Planning and Zoning Commission

March 5, 2019

Mustang Ridge Plat 1 – Preliminary Plat

Communication Data Link – Site Plan
Grimes Industrial Park – Parcel 2018-10 of Lot 11
1255 SW 37th Street
FOX P.N. 8630-04F.284

MUSTANG RIDGE
PLAT 1
PRELIMINARY PLAT

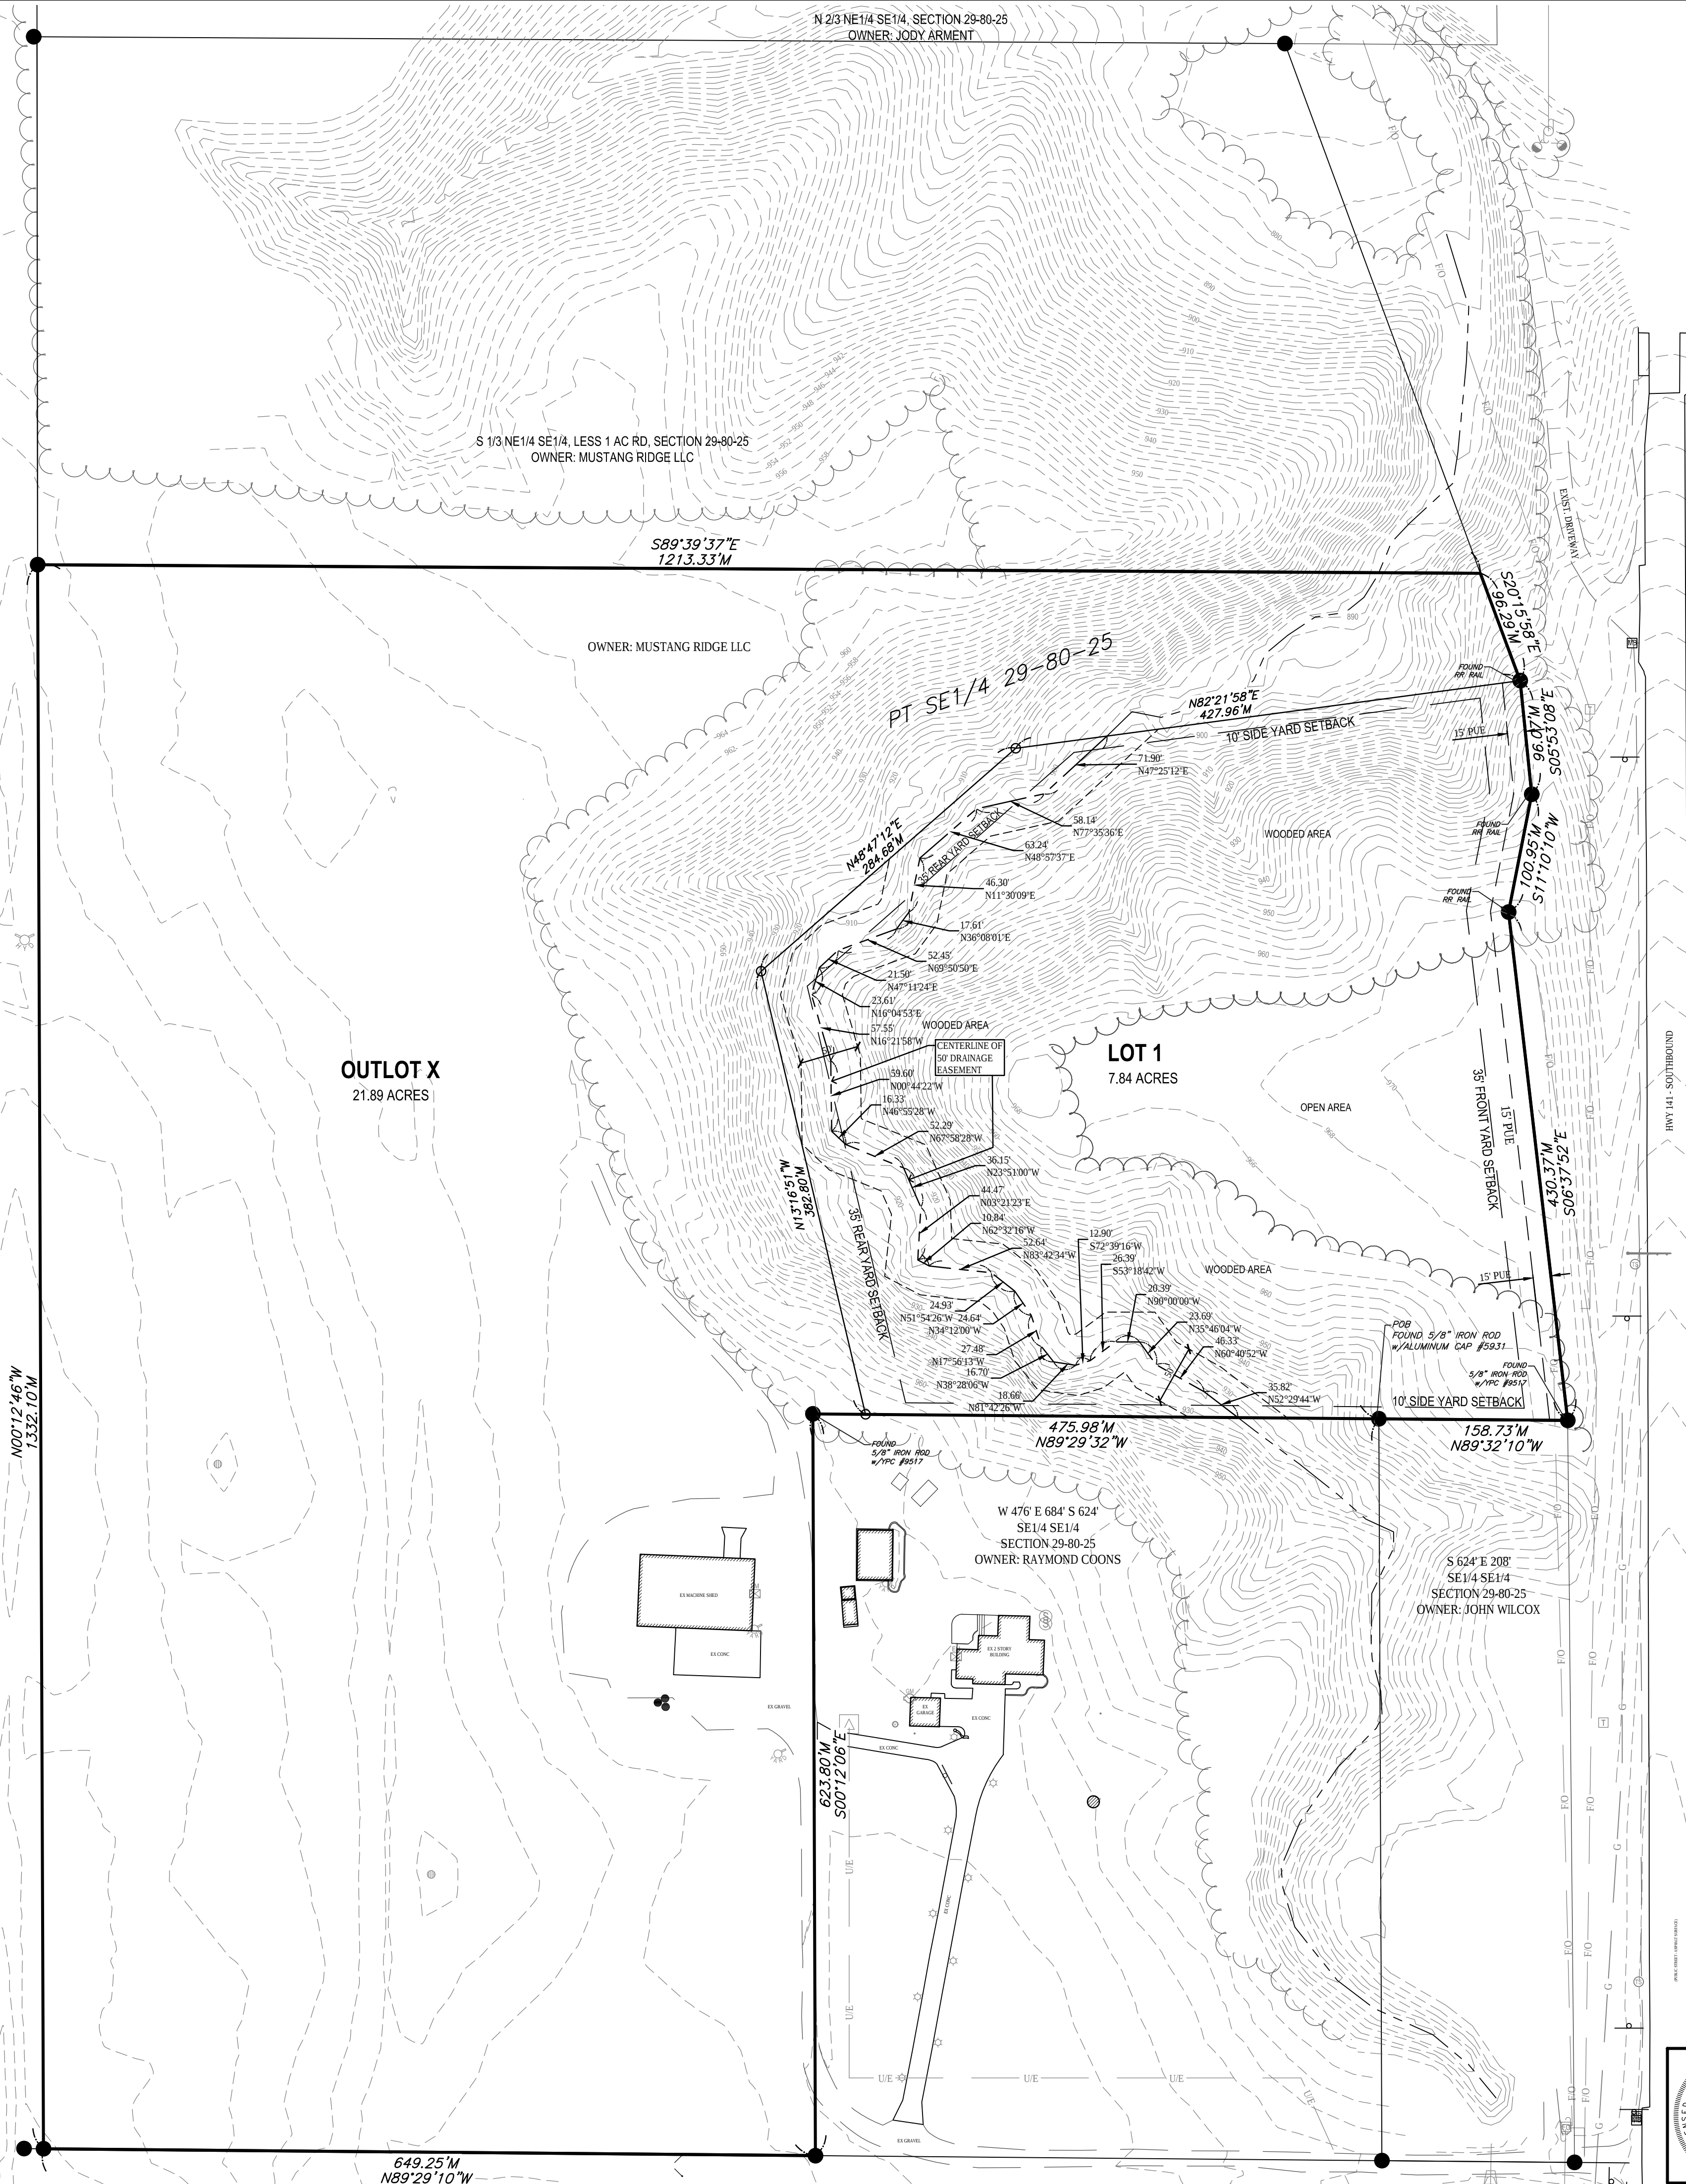
FOX Engineering and City Staff have completed the first review for the Mustang Ridge Preliminary Plat dated December 5, 2018. Please address the following comments:

There is an existing sanitary sewer (8-inch) stub street of NE 21st Street (with capacity of up to 70 gpm). There is sufficient downstream sanitary sewer capacity to service the proposed plat. Lot 1 cannot be served by gravity sewer due to topography and will need to have a private septic system or a grinder pump (lift station) and force main to discharge into the existing gravity sewer system. If Lot 1 desires to connect onto the City of Grimes Sanitary Sewer System, a Development Agreement will be necessary for this Polk County lot to connect to the Grimes system.

There is an 8-inch water main available for connection at the existing east end of NE 21st Street and along the north side of NE Station Crossing. A proposed 6-inch water main (minimum) will be required to service this lot for domestic water service and fire protection. Lot 1 will likely have their own private water well and not connect onto City of Grimes Water System since the parcel will be in the County. If Lot 1 desires to connect onto the City of Grimes Water System, a Development Agreement will be necessary for this Polk County lot to connect to the Grimes system.

It is assumed that the proposed storm sewer will discharge directly into the existing intermittent stream channel adjacent to the development and/or HWY 141 ROW. The subject parcel will have its own storm water detention. It is unknown whether gas, phone, and electrical is available to this site.

The Parks & Trail Plans do not show any proposed parks or trails within the proposed preliminary plat. It is assumed that Outlot X will eventually be annexed into the City of Grimes and parkland dedication will be addressed during the platting process. Lot 1 is planned to remain in Polk County and Grimes ordinance does not require trails and/or parkland dedication for Polk County Developments. Lot 1 is not proposing to a trail and/or sidewalk connection to the City of Grimes due to existing terrain, cost, and Polk County does not require sidewalks.

The preliminary plat is within the City of Grimes planned annexation area. The City of Johnston has plans to annex the adjacent property to the east, thus making this parcel an “island” which is not allowed per Iowa Code. The Mustang Ridge Developer had previously submitted a development and annexation concept plan which included this lot within the city limits. The Developer has recently entered into a Development Agreement with the City of Grimes regarding future annexation.

SHEET TITLE:
SOUTH SIDE ELEVATION
WEST SIDE ELEVATION

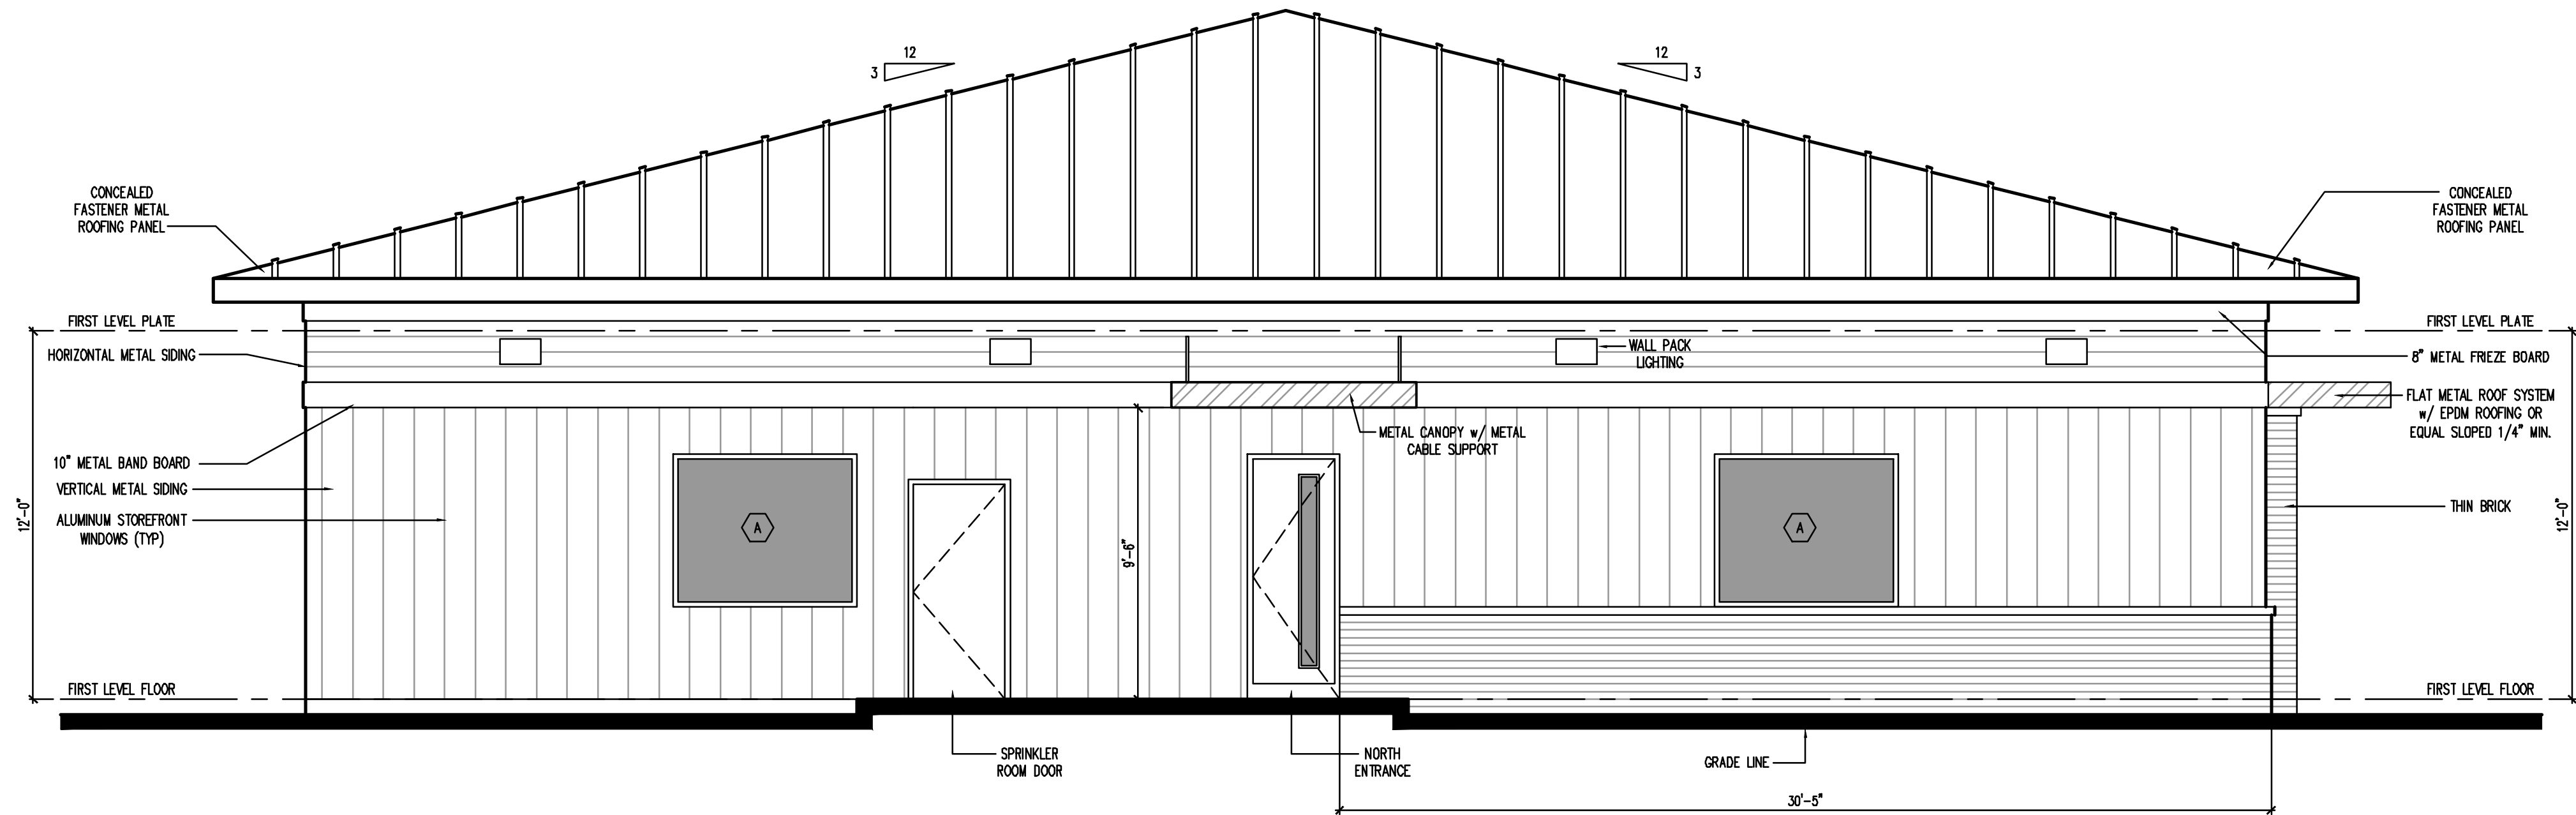
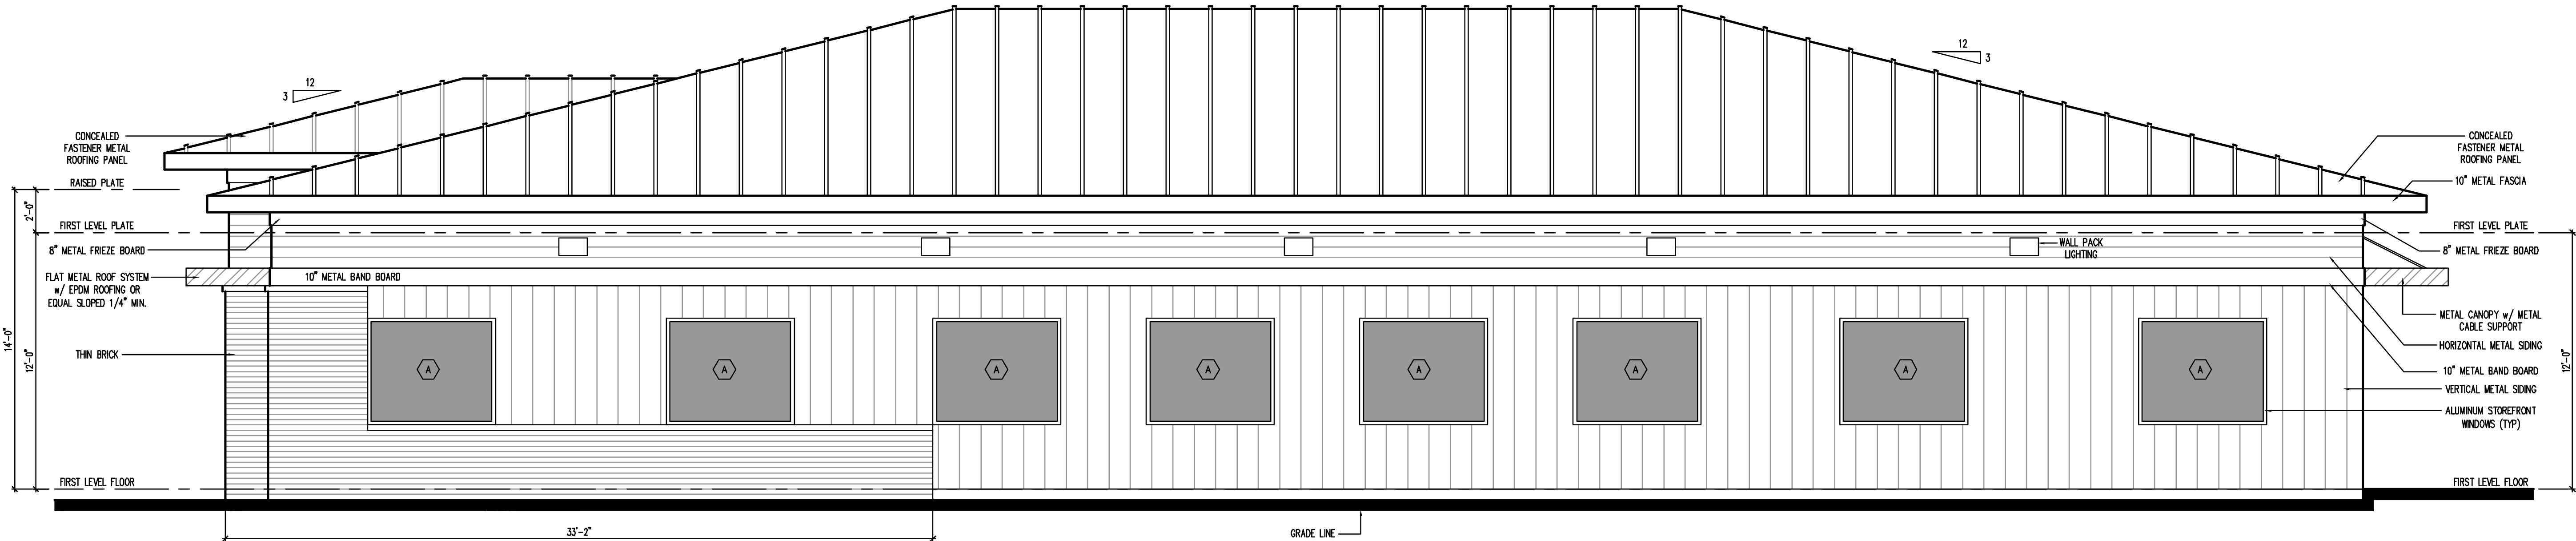
4. Please attach the Elevation Plans to the Site Plan (1 full document is required).
5. It appears that the elevations provided meet or exceed the architectural standards listed in the Grimes Code 165.51.
6. It is highly recommended that you bring detailed building materials and color schemes with you to P & Z.
